# Assessment of Dam Safety Coal Combustion Surface Impoundments (Task 3) Draft Report

**Kentucky Utilities**

**Ghent Generating Station**

December 8, 2009

FIGURE 12A

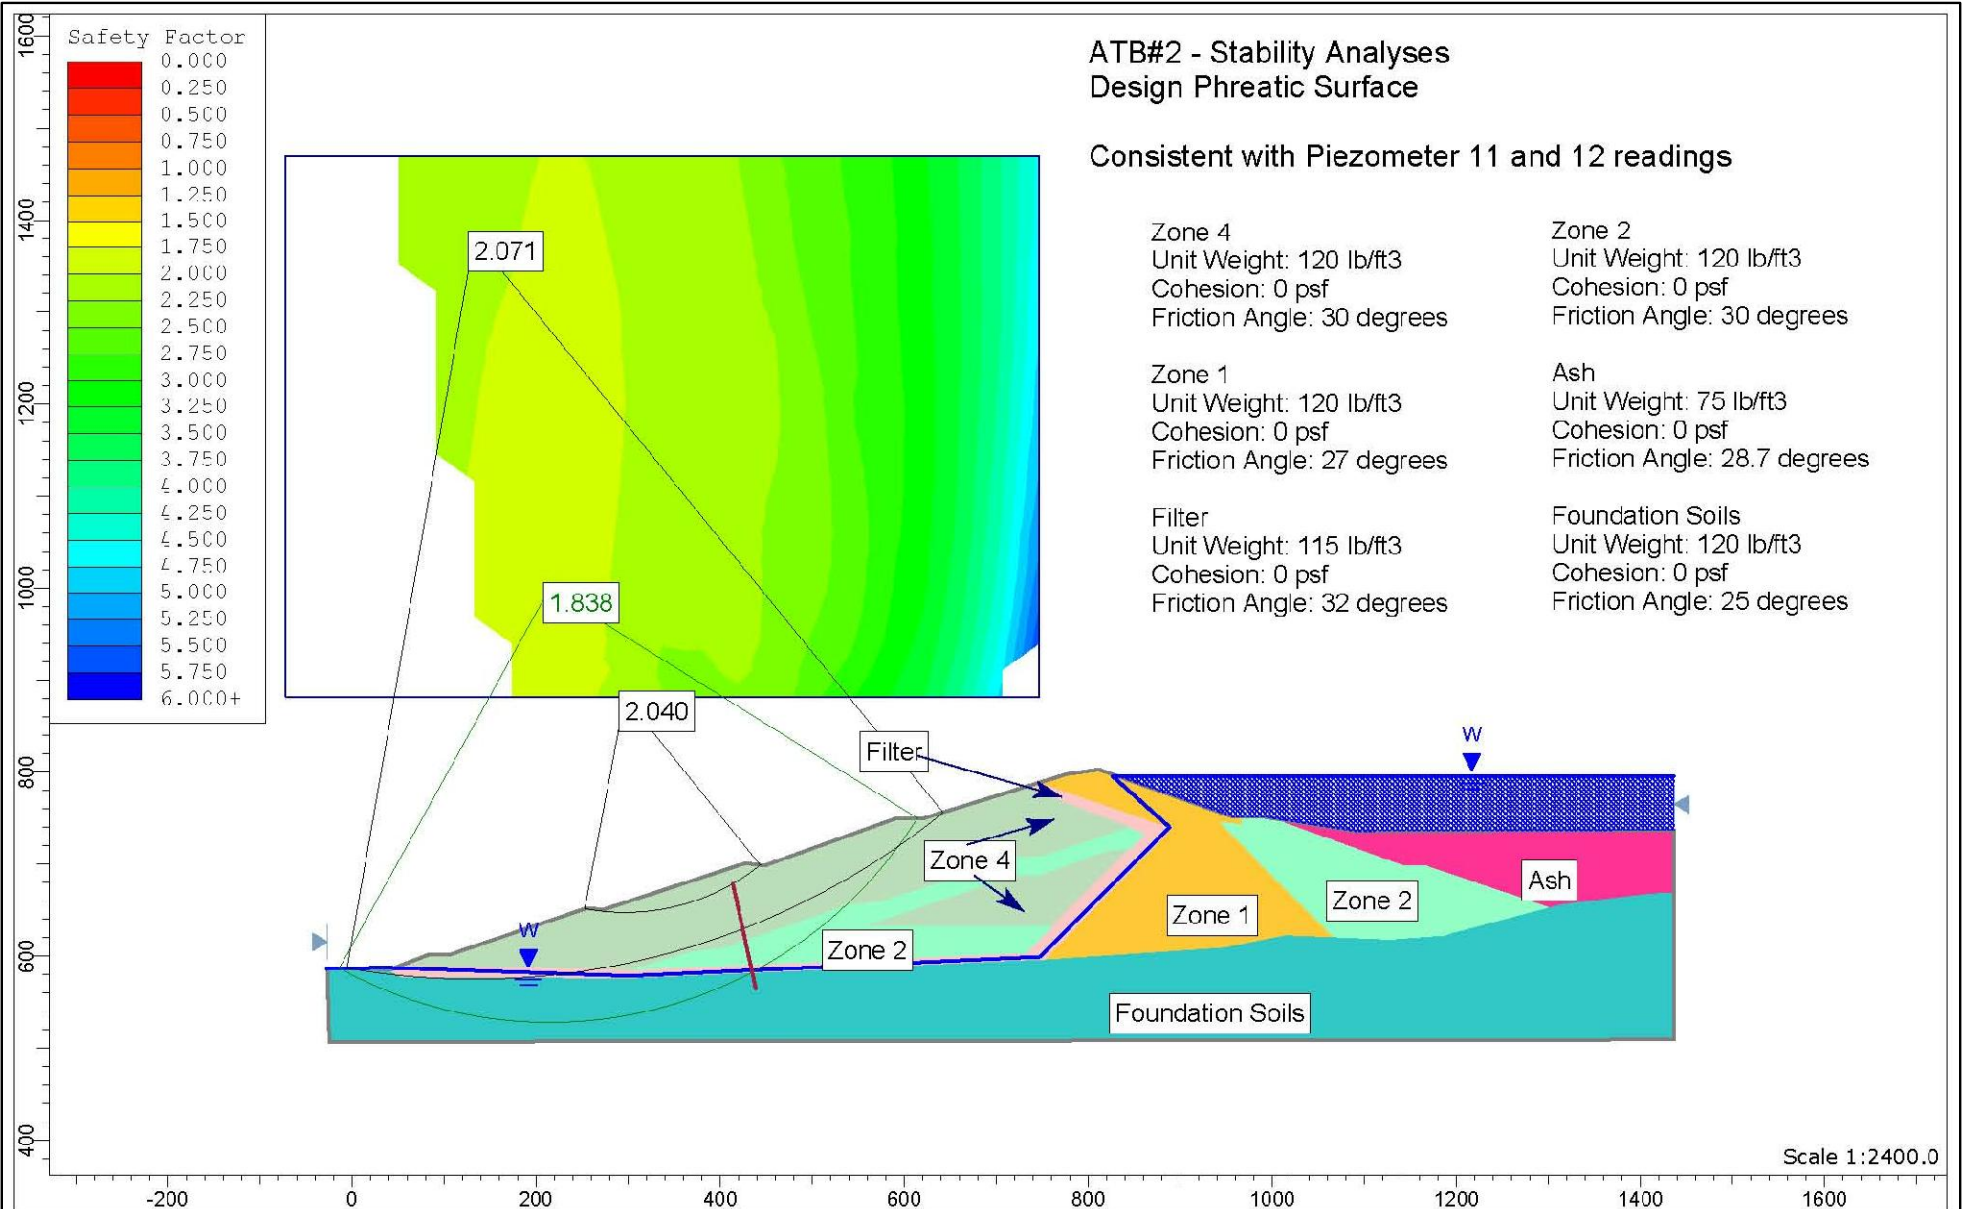
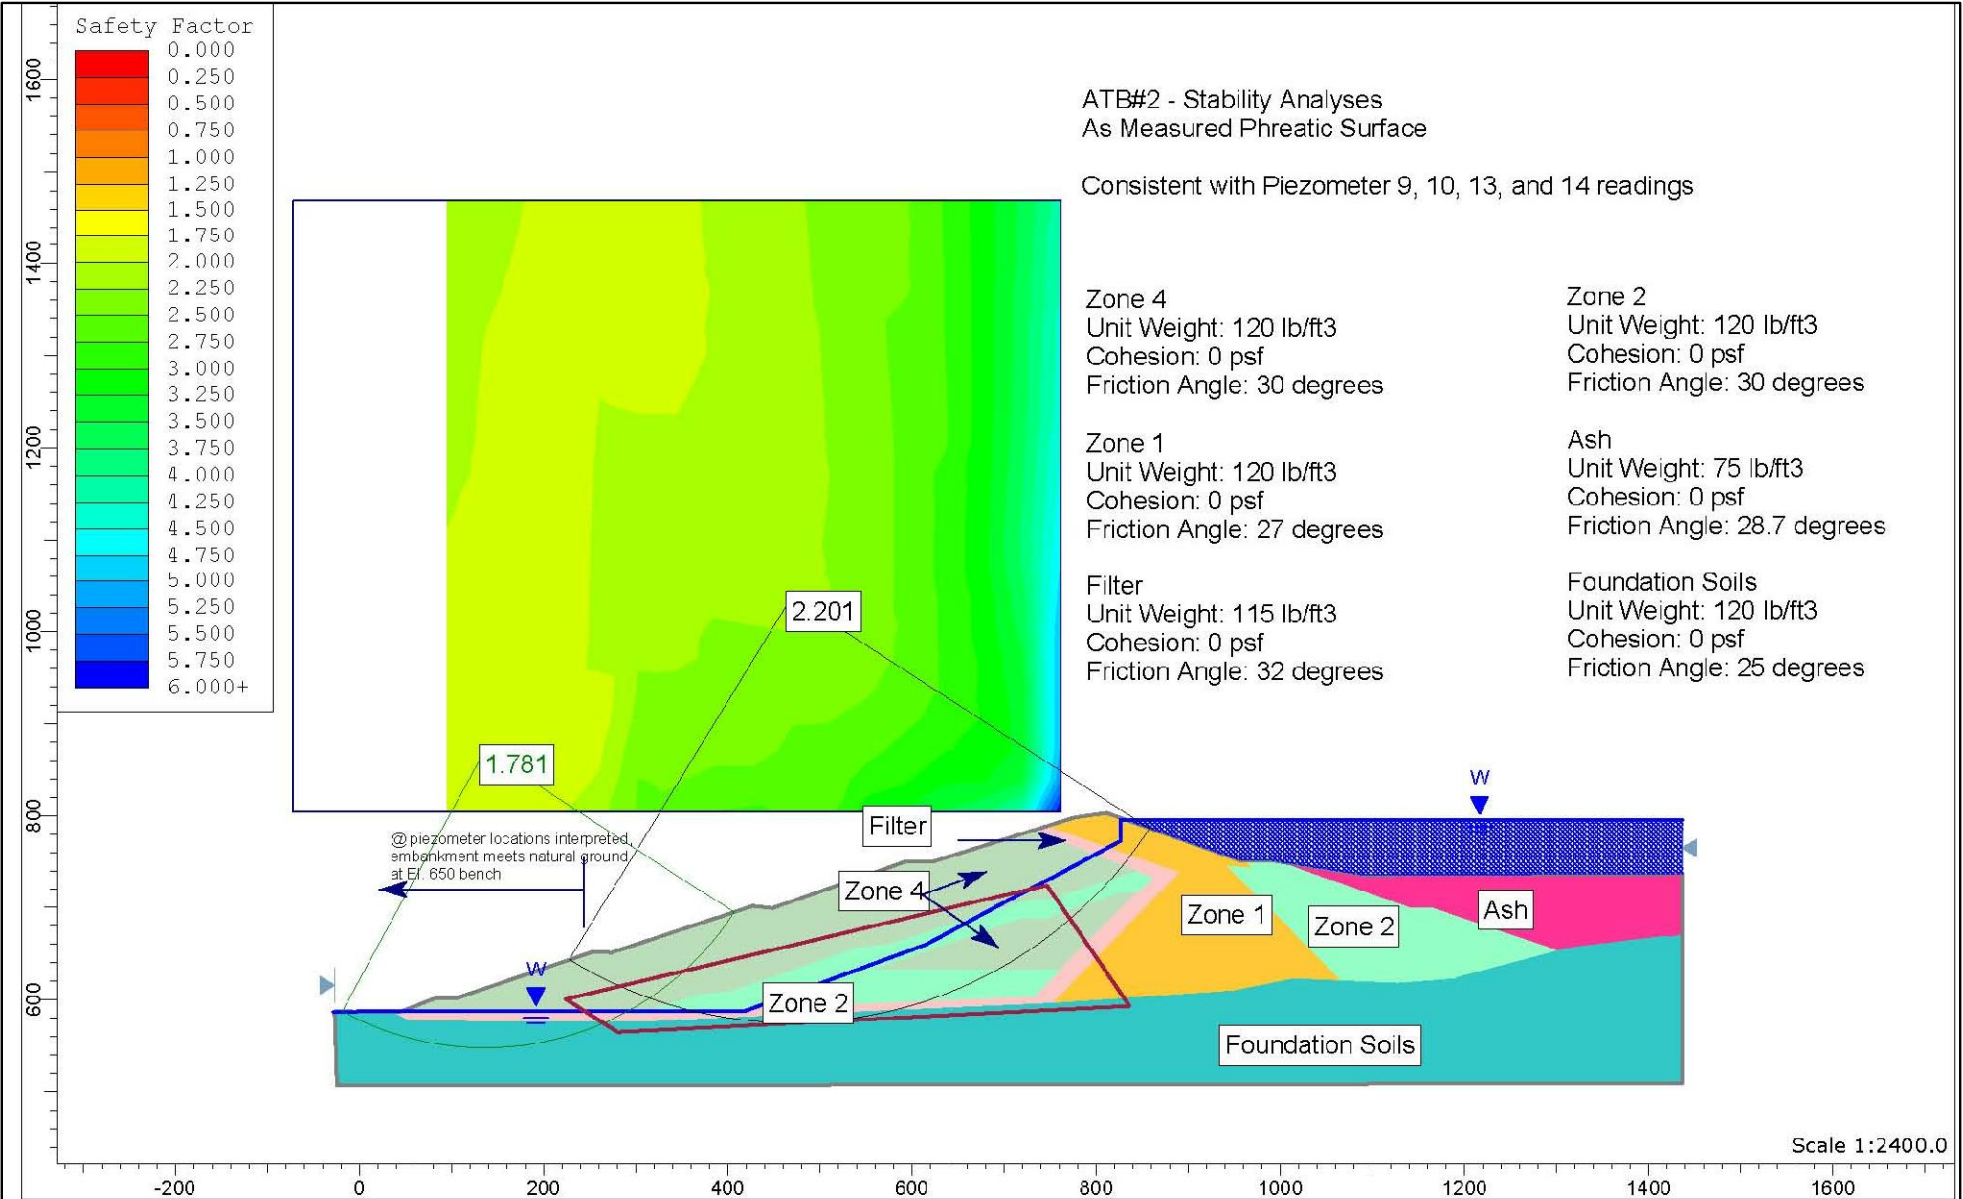
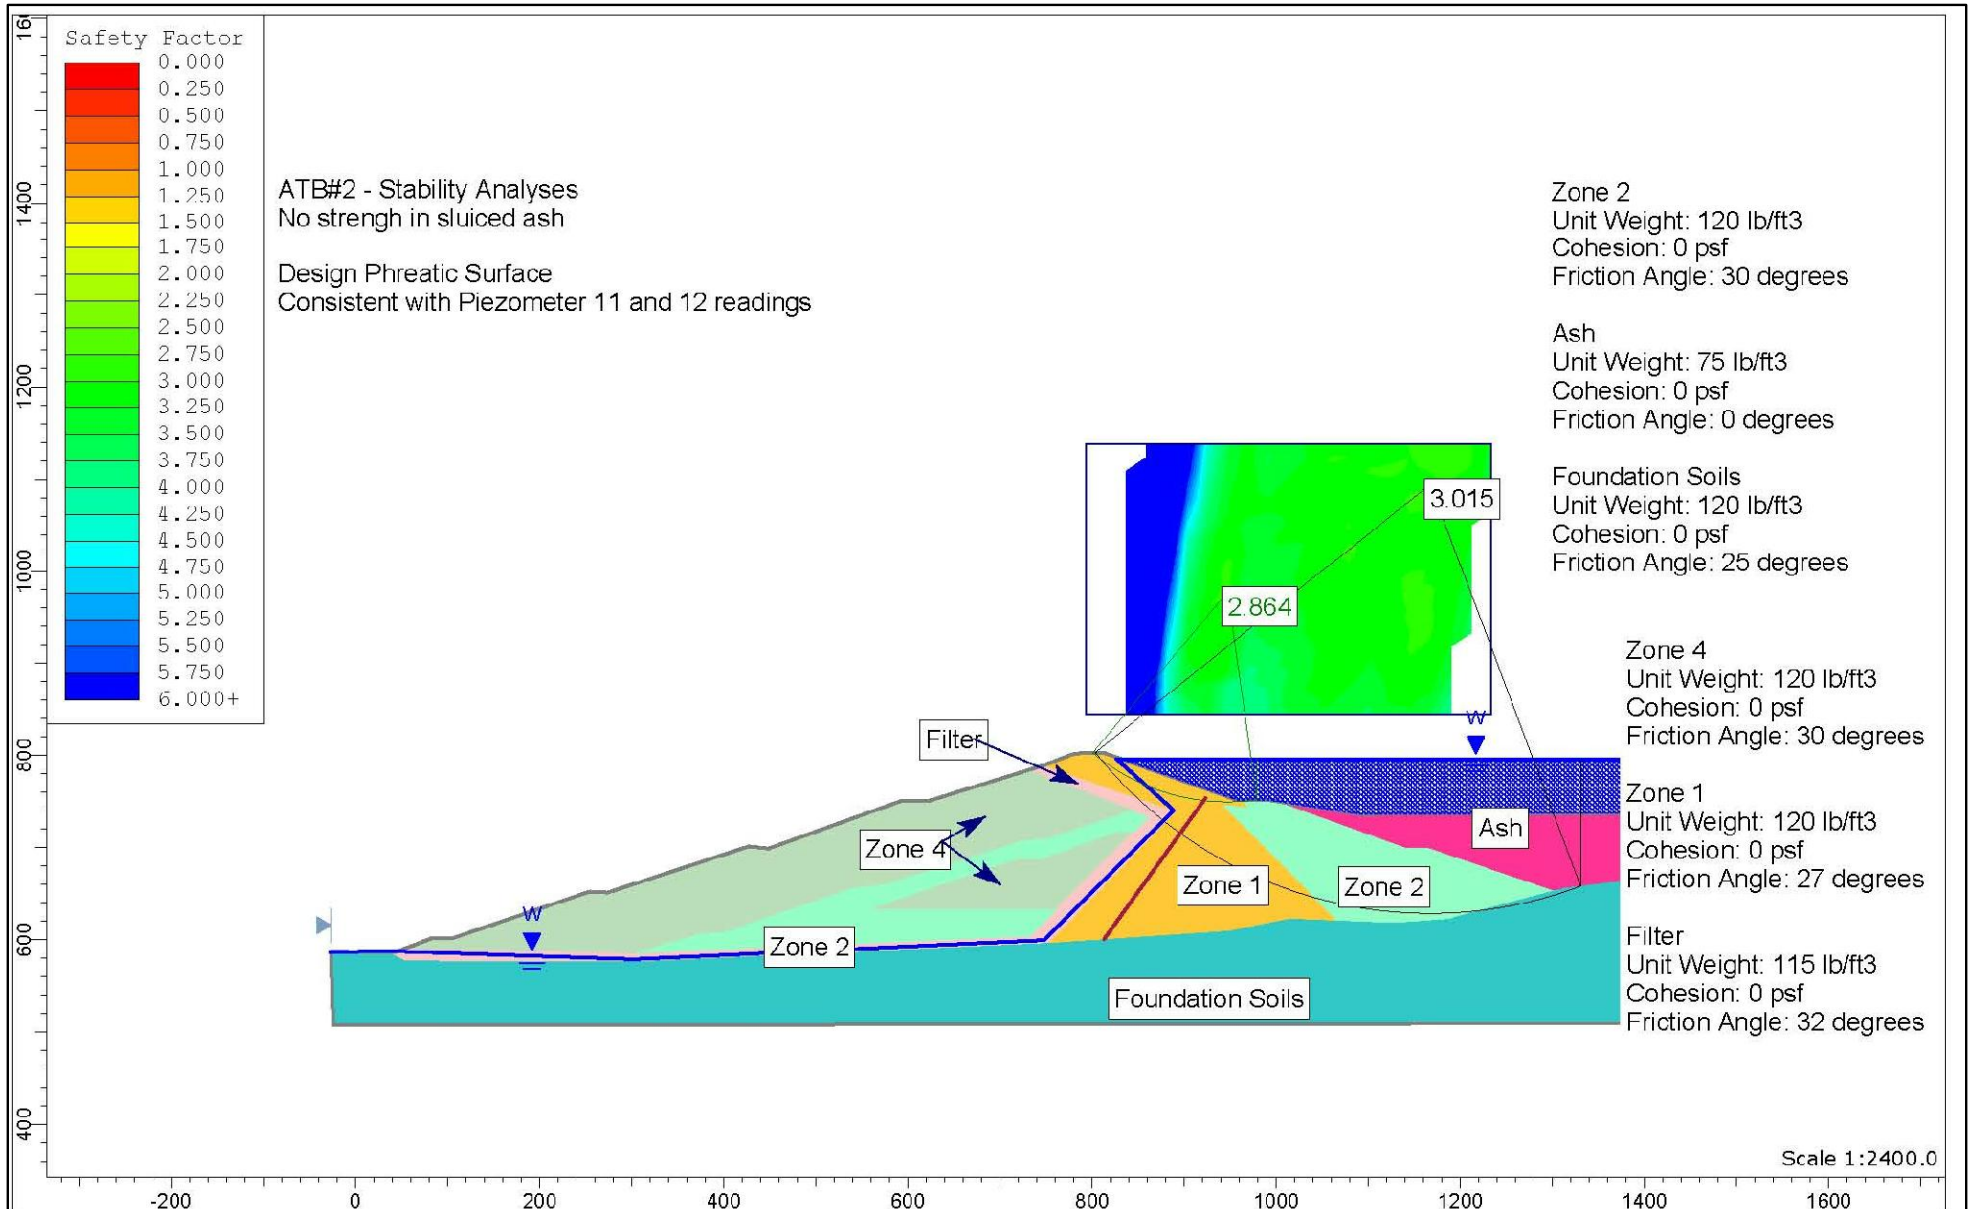
CHA recreated the maximum height cross section used in FMSM’s analyses using the computer program Slide™ and the soil properties from Table 8 above to confirm these results. CHA performed these analyses to verify the calculated minimum factors of safety because the record drawings showed very shallow surfaces representative of a surface slough rather than a deep seated failure as the worst case scenario, whereas FMSM had reported deep seated failure conditions in the design report. These shallow surfaces are sometimes an anomaly of the computer programs used for the analysis and verification of factors of safety against deep seated slip surfaces is warranted.
